OTWAY WATER BOOK 51

Review of Jacobs “Low Flow Recommendations for Boundary Creek”

Final Draft – 04
11 July 2018.

Otway Water Book 51 critically reviews the 2018 Jacobs “Low Flow Recommendations for Boundary Creek,” commissioned by Barwon Water.⁽²⁷⁾

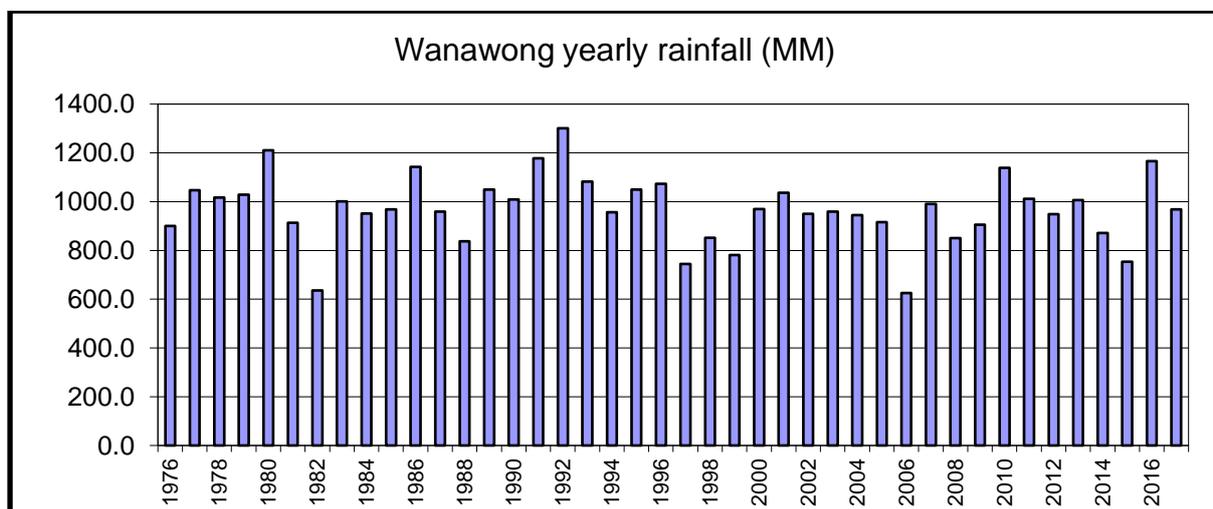
Figure 1-3 on page 9 states that 2016 was a record dry year with 3,449 ML being extracted from the Borefield. The mention of a dry year gives the impression that the extraction of 3,449 ML is justifiable. Is this the case?

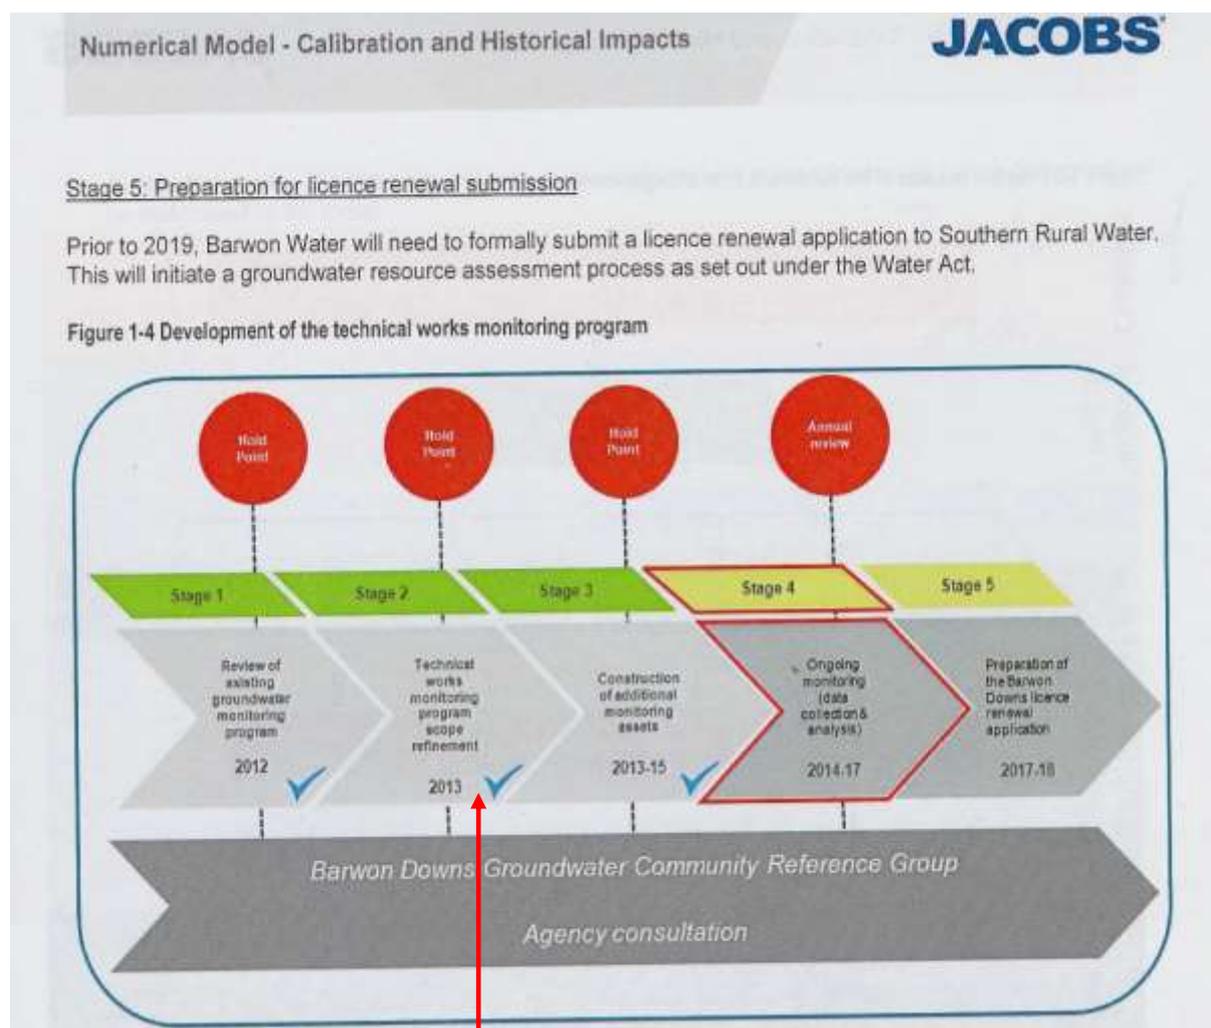
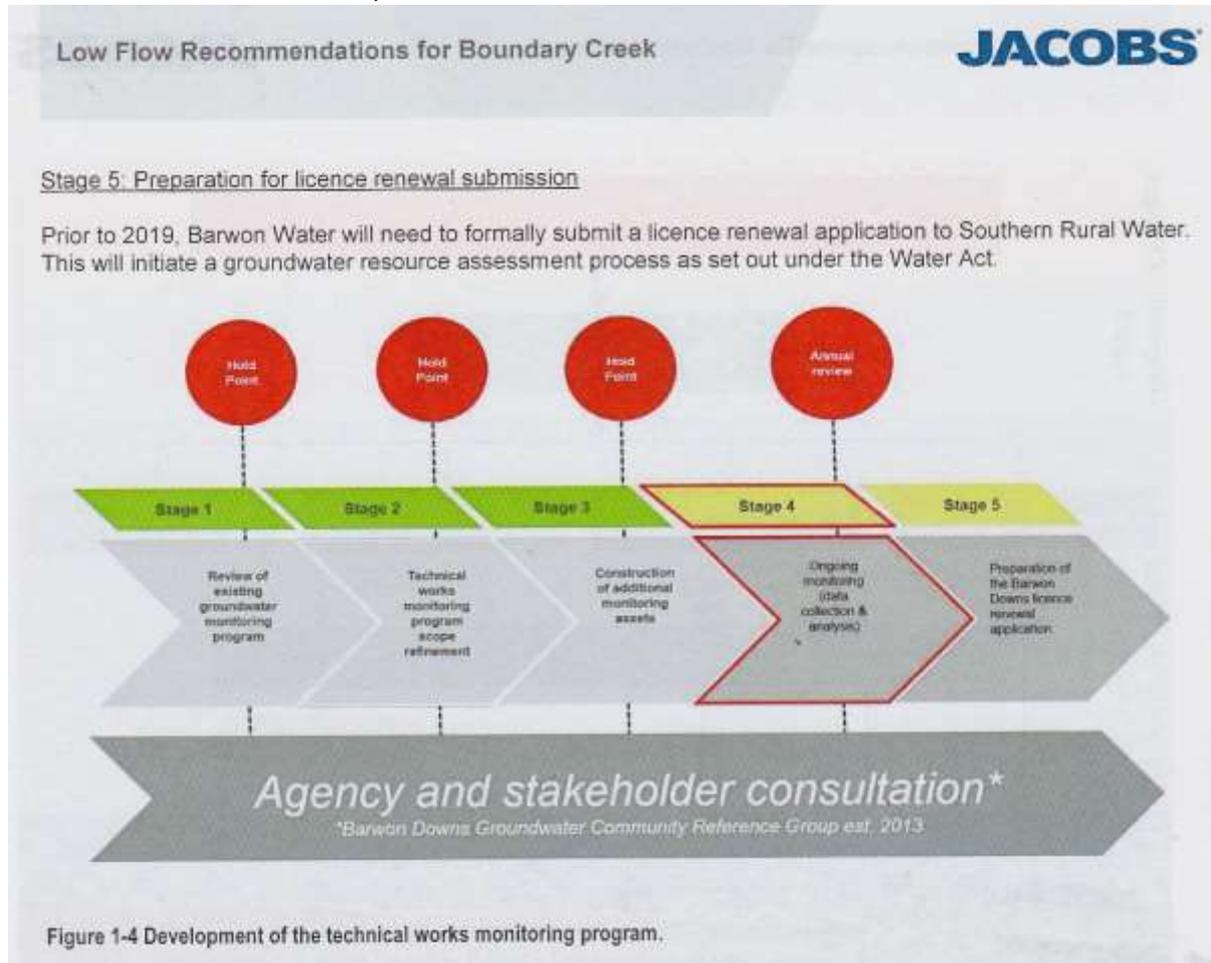
Figure 1-4 (see figure below) found in the June 2017 Numerical Model report⁽⁴¹⁾ continues to portray the myth that local input has been involved and been part of the development of the 2102 Barwon Downs Monitoring Program since its inception. All such figures round this period portrayed the same mistake. Other reports continued to have a similar mis-representation even after the mistake was pointed out to Barwon Water and Jacobs.

The first meeting of the Barwon Downs Groundwater Community Reference Group was 13 October 2013, not as the grey arrow portrays – from inception development stage pre 2012.

Whether this was a purposeful continuation of the myth that local community input had been sought and listened to from the very beginning, one will never know. However, other reports that could have been rectified continued to contain the same mistakes. Eventually, the figure above was modified, and recognition placed on the figure acknowledging that the CRG was first established in 2013. But, no mention was made that it was at the end of 2013.

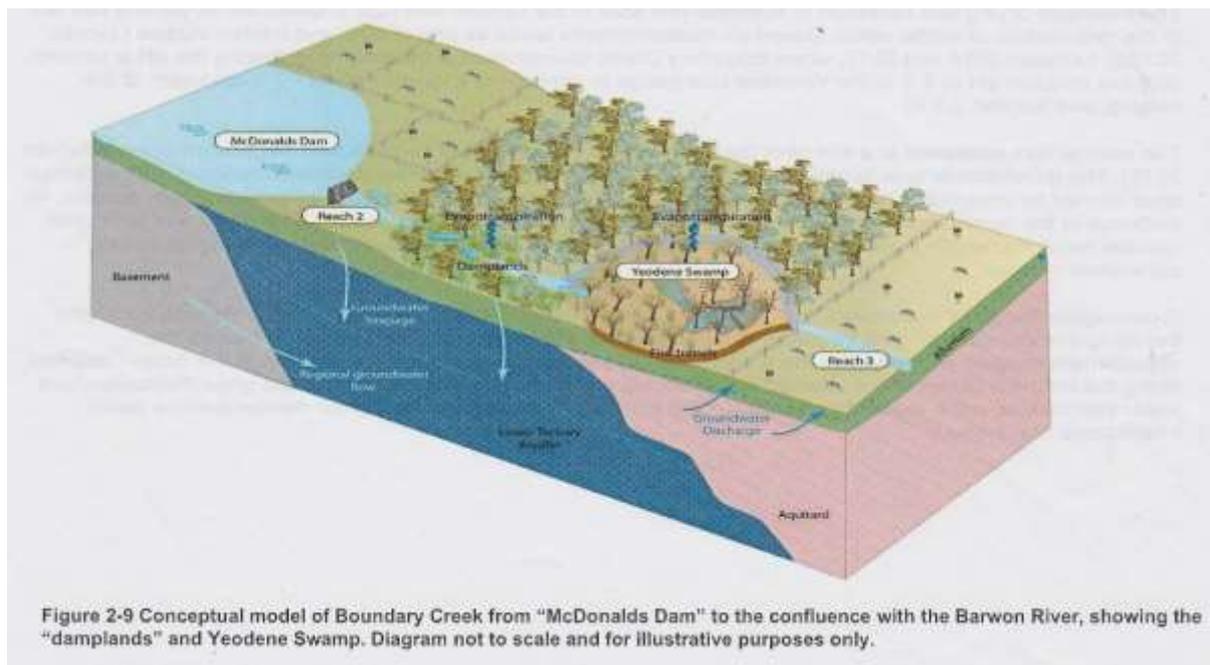
Figure 2-9 has been acknowledged as not to scale and for illustrative purpose only. However, this figure should not portray incorrect or doubtful information. For example to show that the aquitard is present under the entire length of the Big Swamp has never been established. In fact this is one of the data gaps that has to be determined to assist in the restoration of the Big Swamp and Boundary Creek (see Appendix 22, pages 195-197). Appendix 22 contains pages from Appendix C taken from the Scope of Works submitted to Southern Rural Water, 20 December 2018. At the bottom of page 6, question 4 and the follow on discussion on page 7, clearly shows that no work has been undertaken to find out whether the Big Swamp is directly connected to, or is separated from the Lower Tertiary Aquifers by an aquitard. Figure 2-9 below is a misrepresentation.

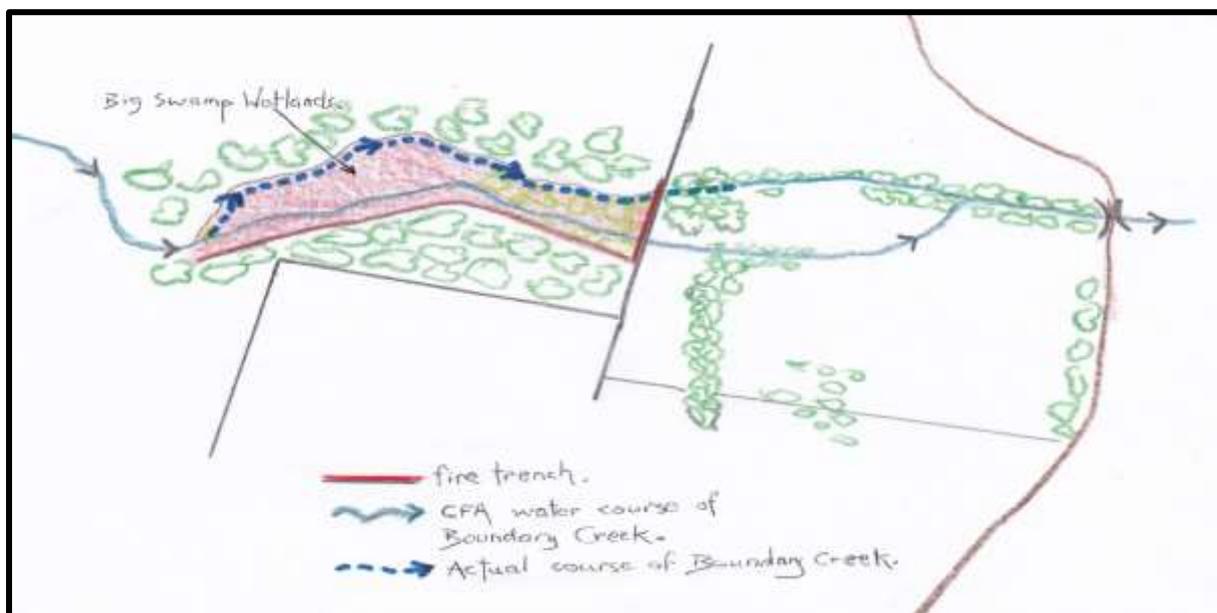
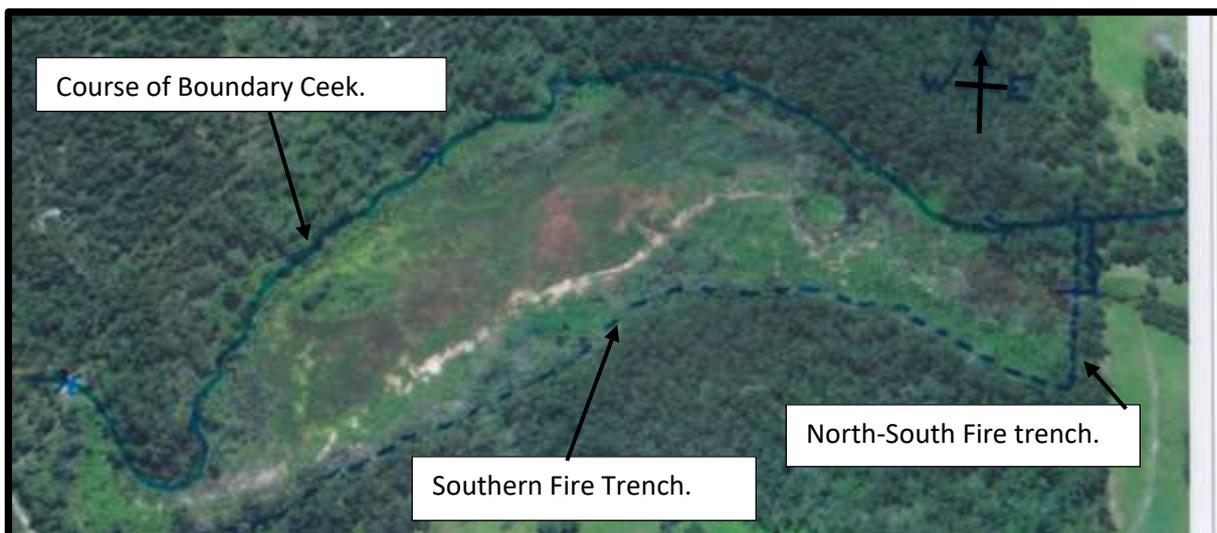
However, this statement is wrong... *“There is one trench along most of the southern margin of the swamp and another that is orientated east-west near the downstream extent of the swamp.”*

Actually, the southern trench runs in an east-west direction and the trench at the downstream extent of the swamp runs in a north south direction.

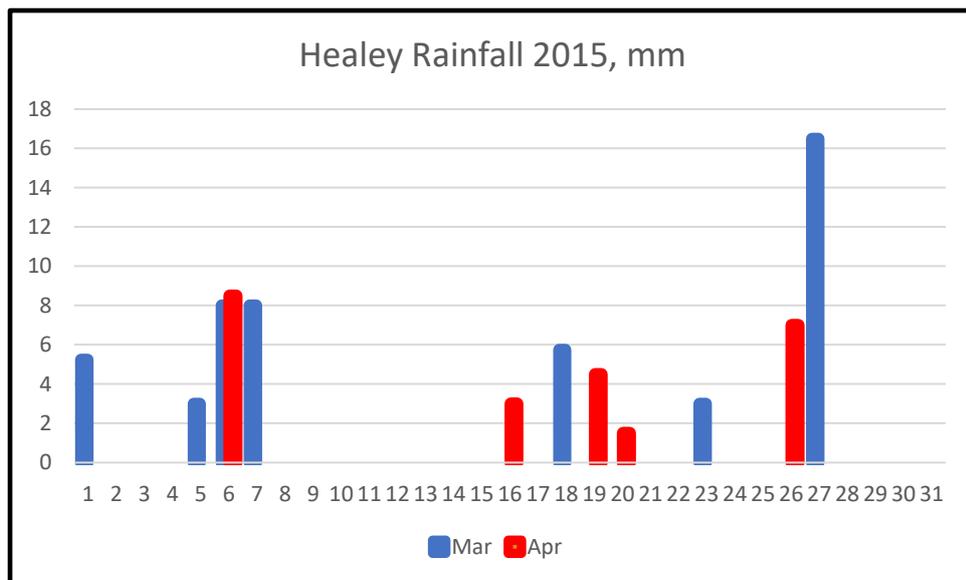
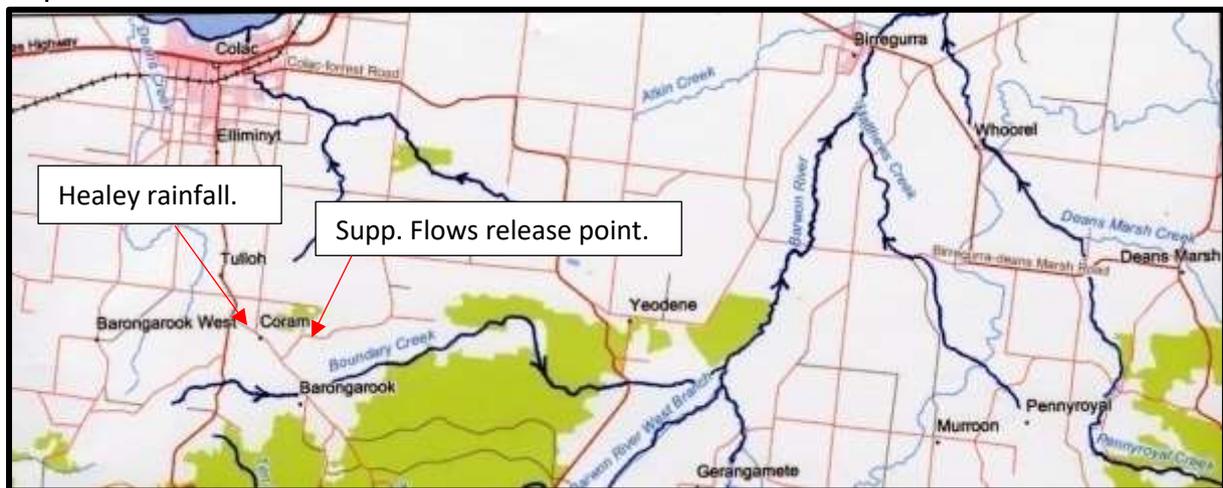
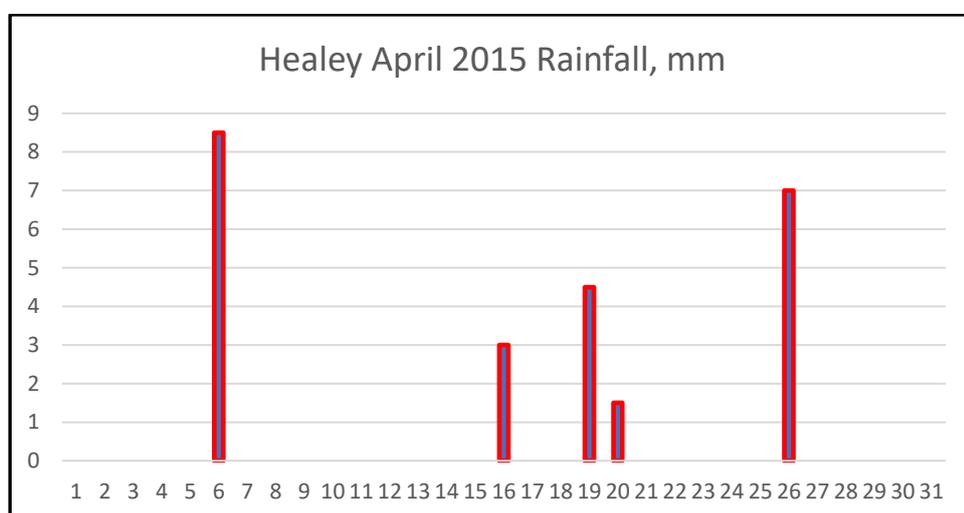
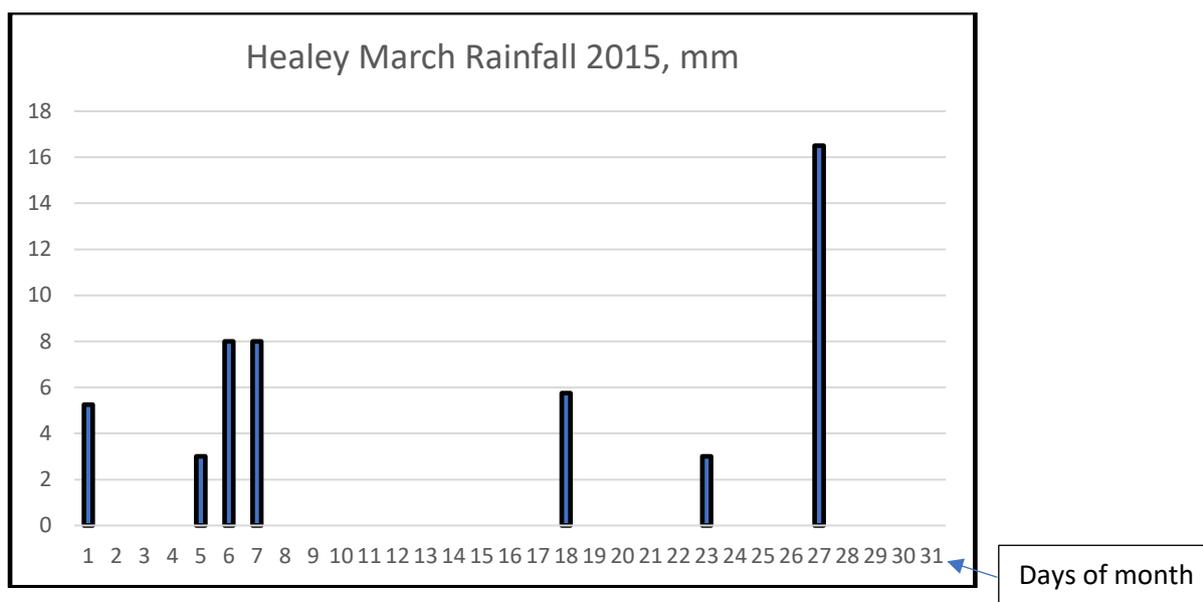
“As shown in Figure 2-13 the 2 ML/day release contributes significantly to the baseflow in Reach 1 during the summer months. This is most clearly seen in April 2015, when the supplementary flow was ceased for maintenance...”

Firstly, it is extremely difficult to “clearly” see what is being pointed out in the April 2015 flow patterns – the Jacobs’ graph does not show the fine detail needed.
